## ZHL-4240+ PCN Report

AN-60-073

As a result of the introduction of a RoHS compliant version (+), non heatsink version, and assembly option at an alternate qualified Mini-Circuits facility, the replacement part has been judged by the Mini-Circuits Engineering team as a suitable replacement for the existing ZHL-4240<sub>0</sub>.

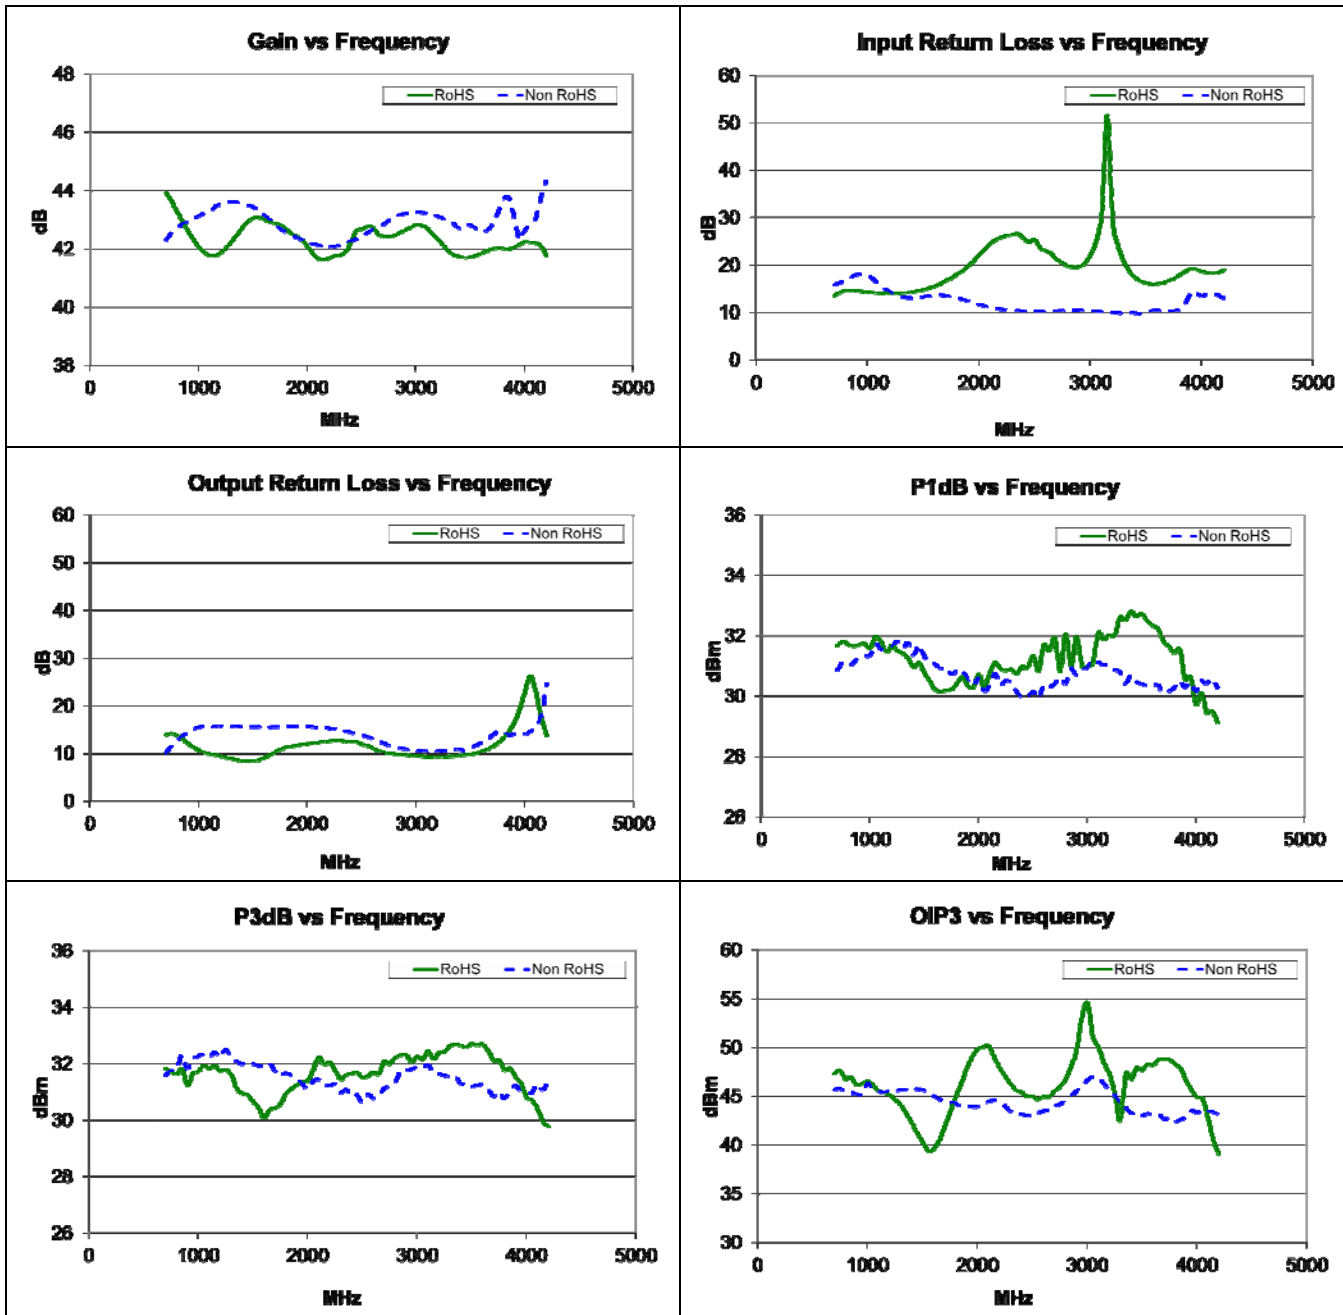
- 1) FIT and FORM are compatible with minor change: Create non heatsink version
- 2) Functional changes as follows:

<b>Parameter</b>	<b>Original Part, ZHL-4240</b>	<b>Replacement Part, ZHL-4240+</b>
Gain	40dB min	39dB min, 42dB typ, 47dB max
Gain Flatness	+/-1.5dB max	+/-1.8dB max, +/-1.3dB typ
P1dB	28dBm min	28dBm min*, 30dBm typ *27dBm at 3700-4200MHz
P3dB	N/A	29dBm min**, 31dBm typ **28dBm at 3700-4200MHz
Supply Current	0.9A max	1A max
